Countries: CANADA, UNITED STATES **Document ID:** IK0800538
Availability: ISIS, Fleet!SIS, IsSIR **Revision:** 1
Major System: ELECTRICAL SYSTEM **Created:** 3/10/2017
Current Language: English **Last Modified:** 5/29/2018
Other Languages: NONE **Author:** Charles Schroeder
Viewed: 1558

Title: ProStar SCR Aftertreatment Harness Replacement**Applies To: ProStar with SCR (ISX and N13)**

Figure 2 - Old Style PDM Original Mounting

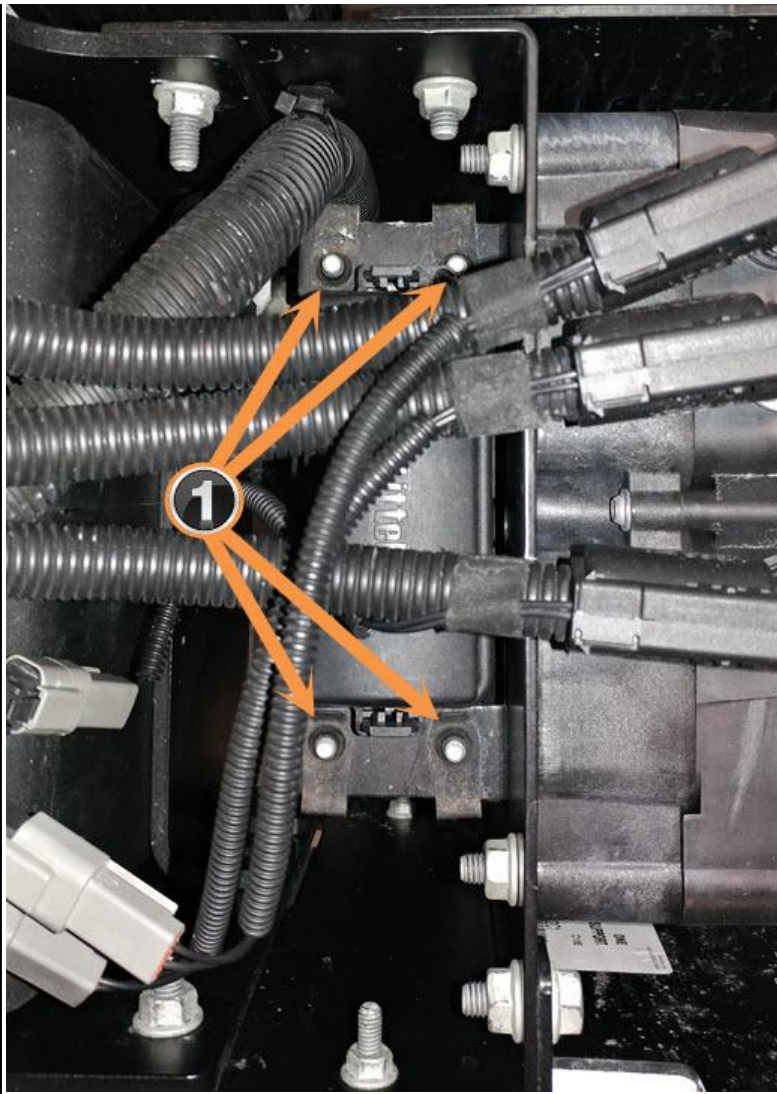
The old style PDM mounts to the bottom of the mounting bracket. The PDM cover locking system on the updated PDM requires the updated PDM is mounted to the top of the mounting bracket. This requires the mounting nut orientation to change. See removal and installation steps below.

1. Use a 10mm wrench or socket to remove the 4 mounting bolts for the PDM (Figure 2)
2. The 4 Extruded U-Nuts (Figure 3) will need to have their orientation flipped 180° vertically
